Addendum #1

Richmond Community College Hendrick Center for Automotive Training 1042 West Hamlet Avenue Hamlet, NC 28345

ADW Project Number: #23014

A402

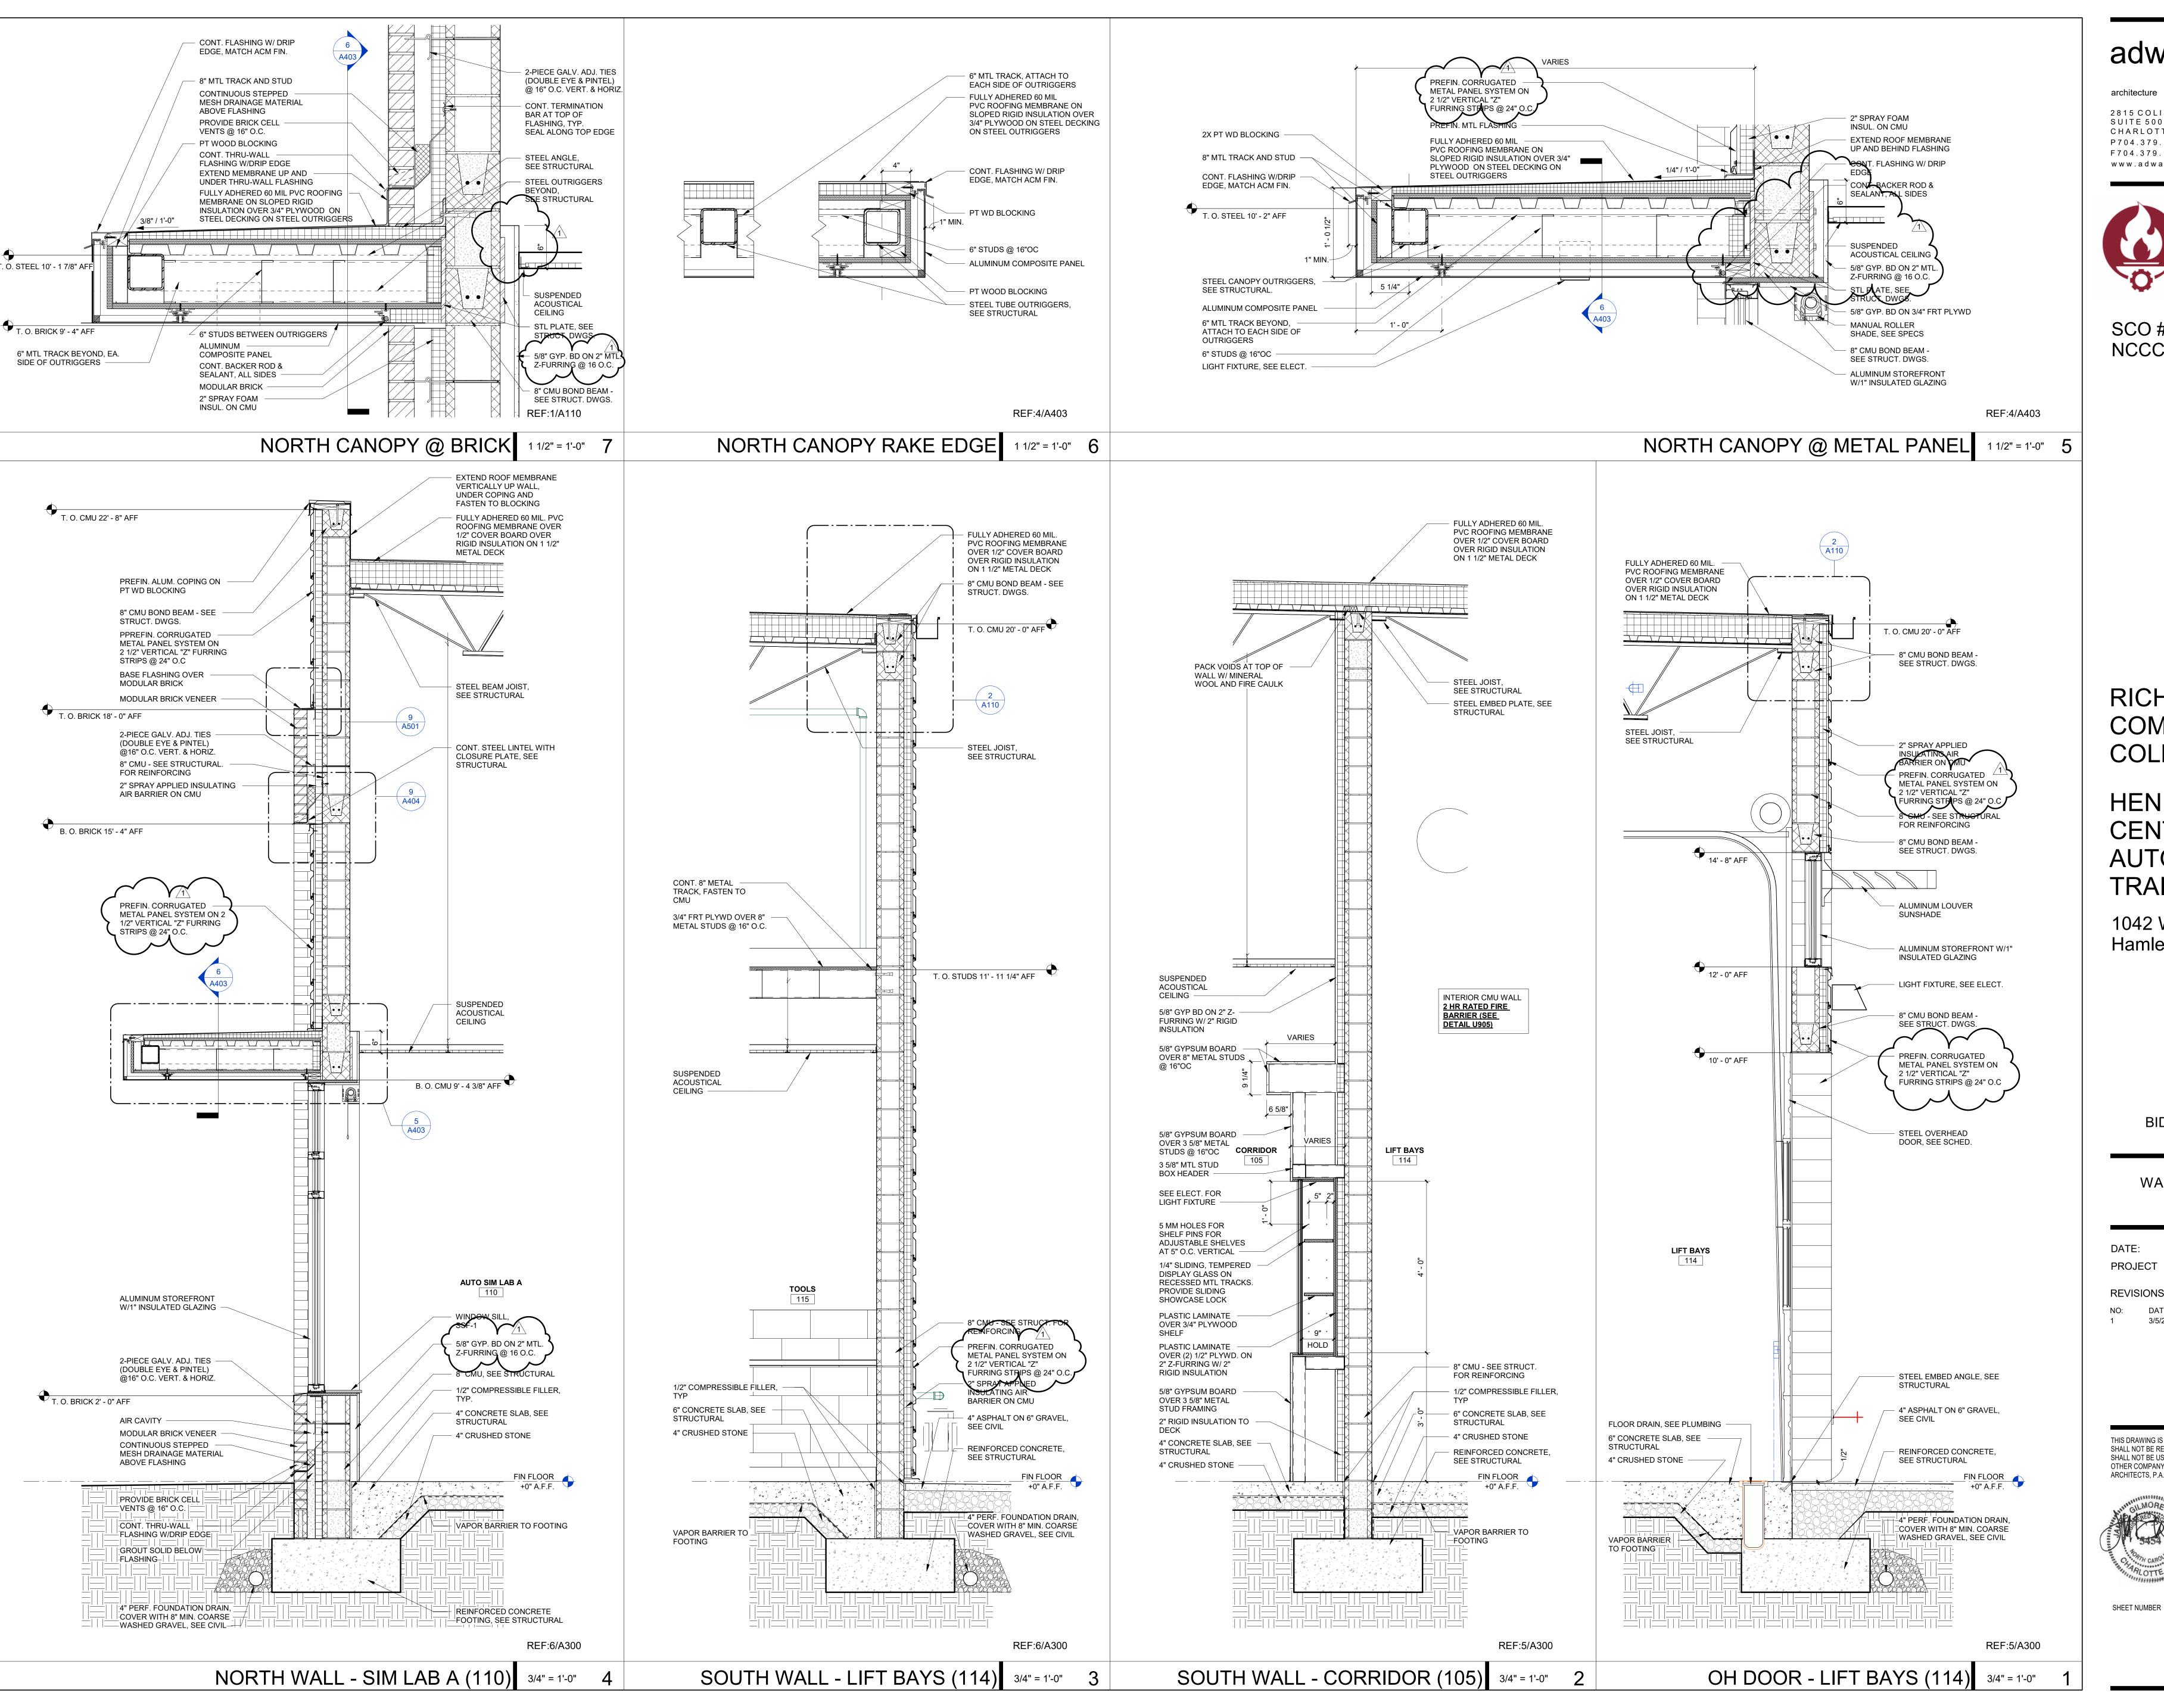
- a. Z-furring strips behind exterior corrugated metal wall panels changed to 2 ½".
 - b. Where interior furring of exterior walls is shown, change 1" Z-furring strips to 2" and delete rigid insulation. Also, stop gypsum board and furring 6" above finished ceilings. Only the exterior walls of the toilet rooms will have 1" Z-furring strips, also without insulation and stopping furring and gypsum board 6" above ceiling.

A701

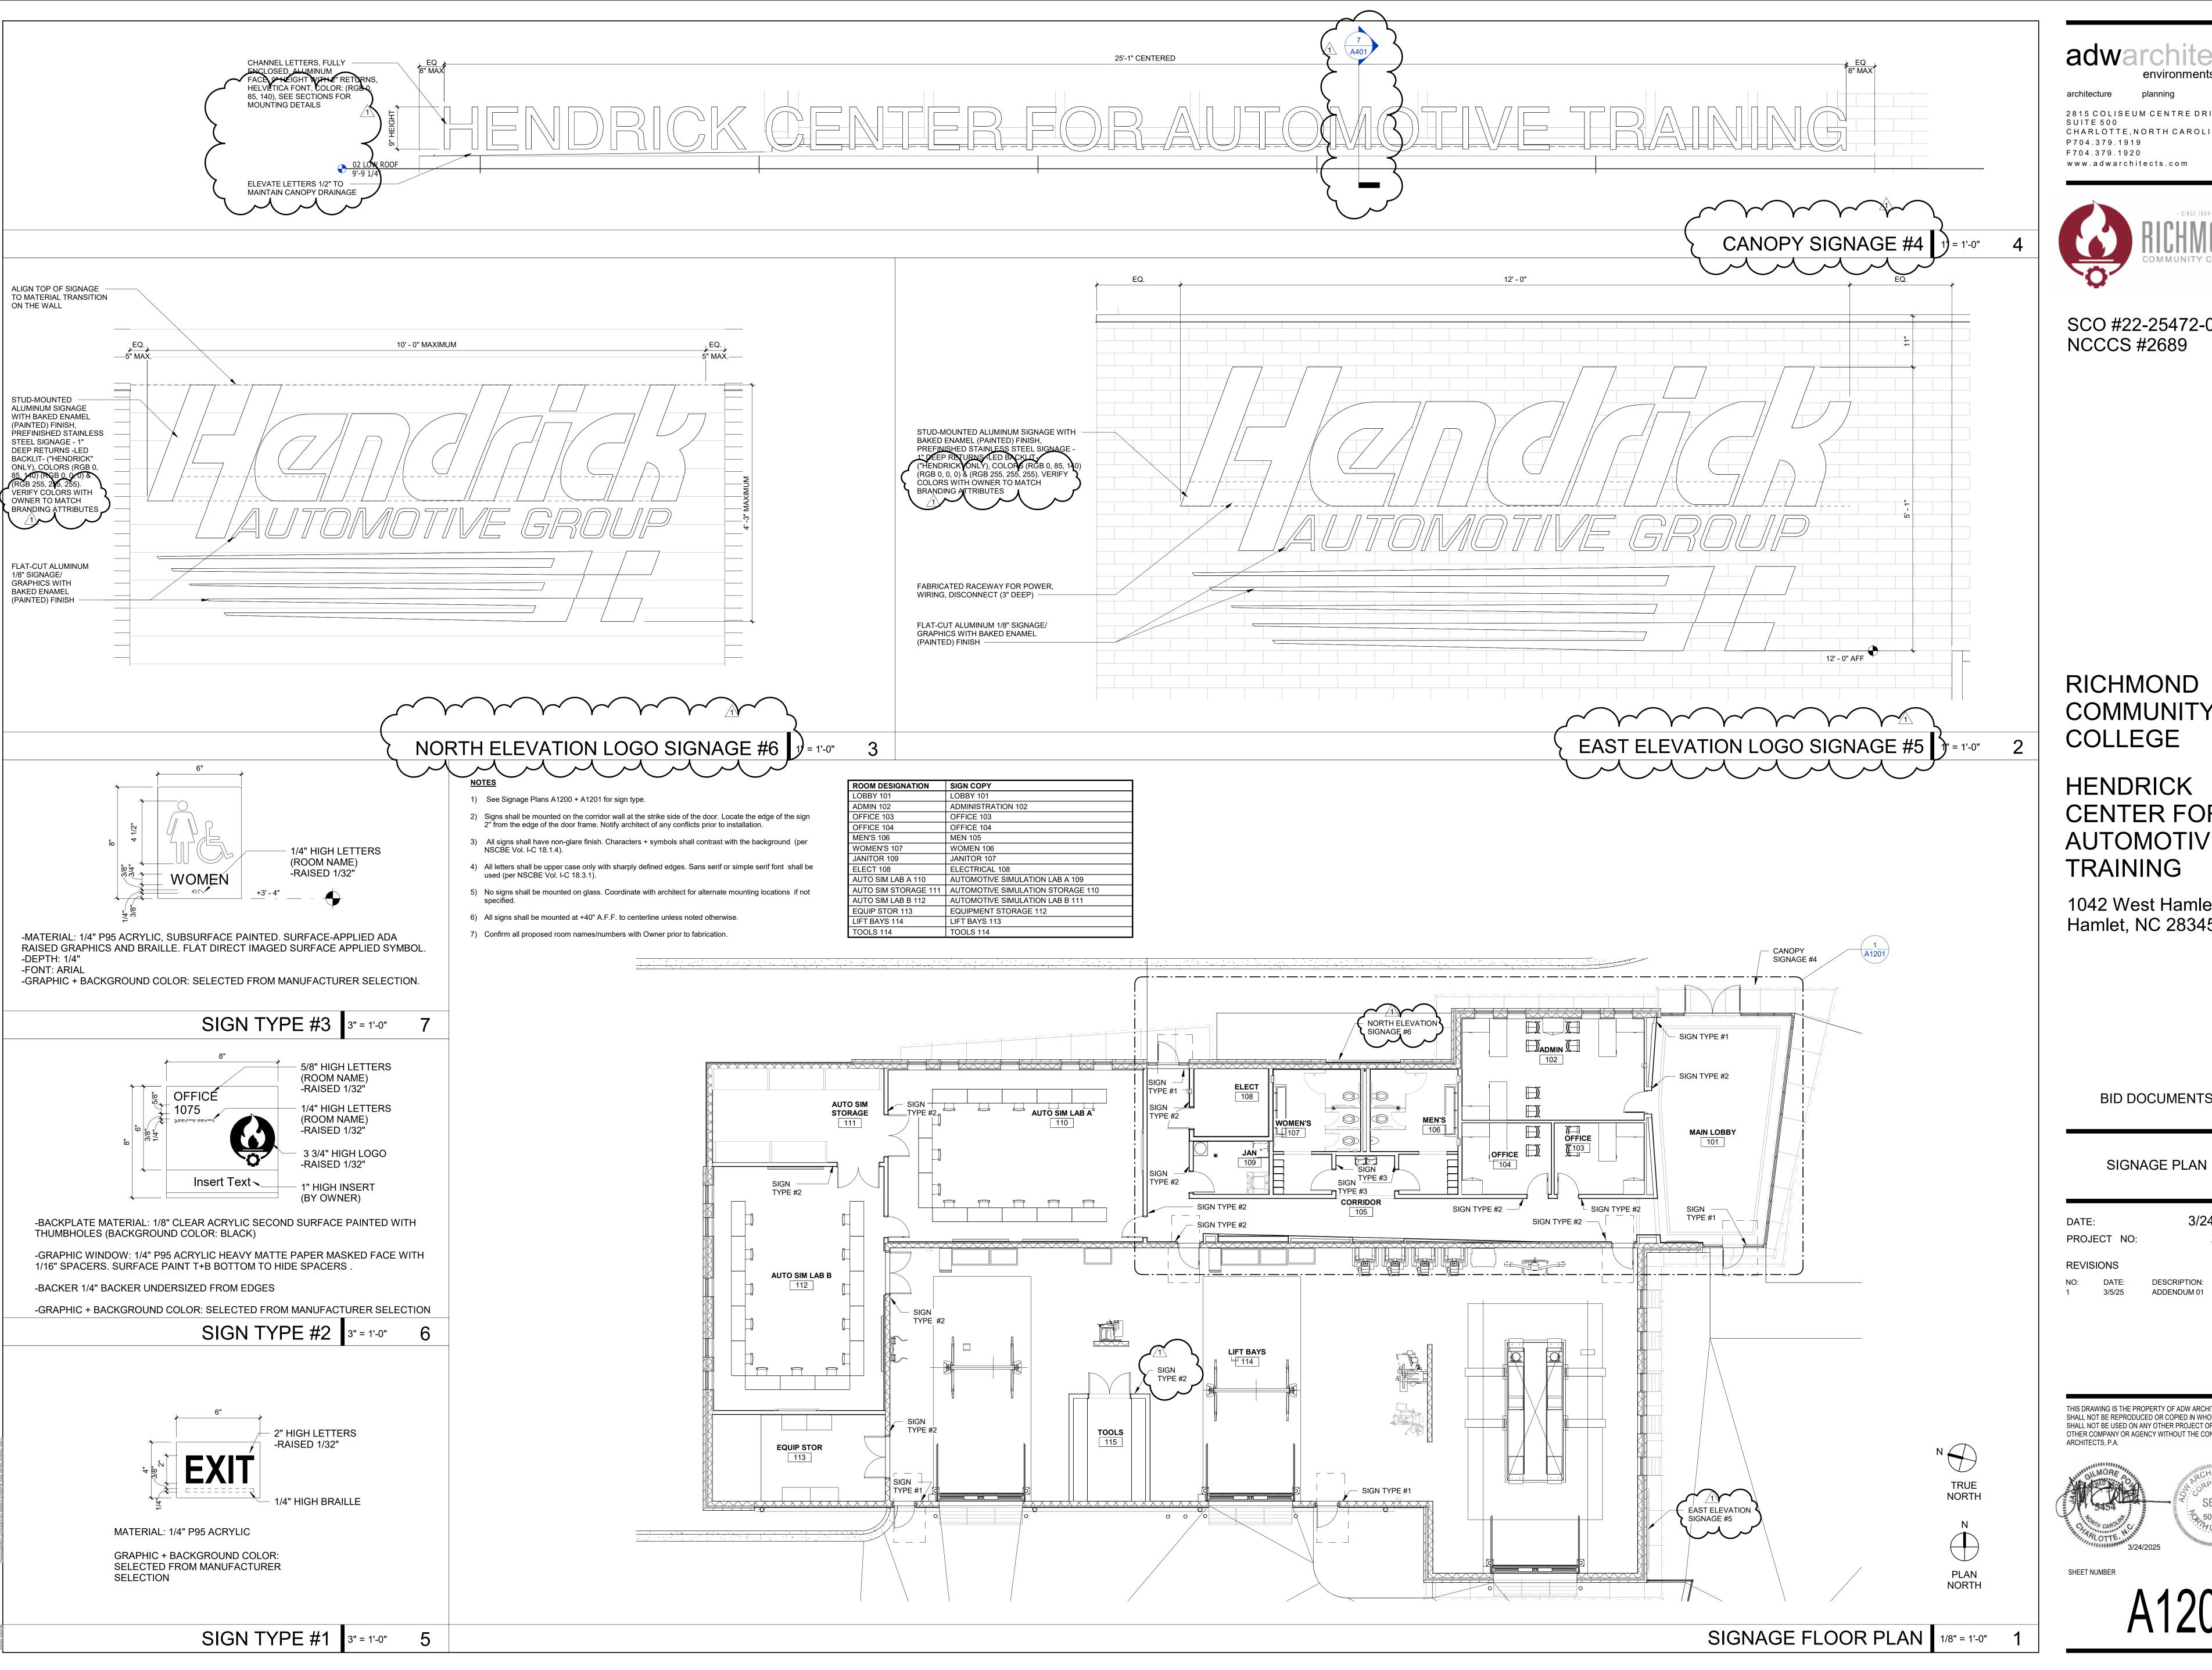
- b. Door Schedule: Door finish changed on interior wood doors.
- 11.)A700
 - a. Interior Finish Legend: P-10 added for interior wood doors.
- 12.)A701
 - a. Detail 1:

- i. Two finish tags were changed from CR-1 to CG-1.
 - ii. Sim Labs floor finish pattern changed.
- 13.)A1200
 - a. Detail 1: Several sign notes changed to better identify signs.
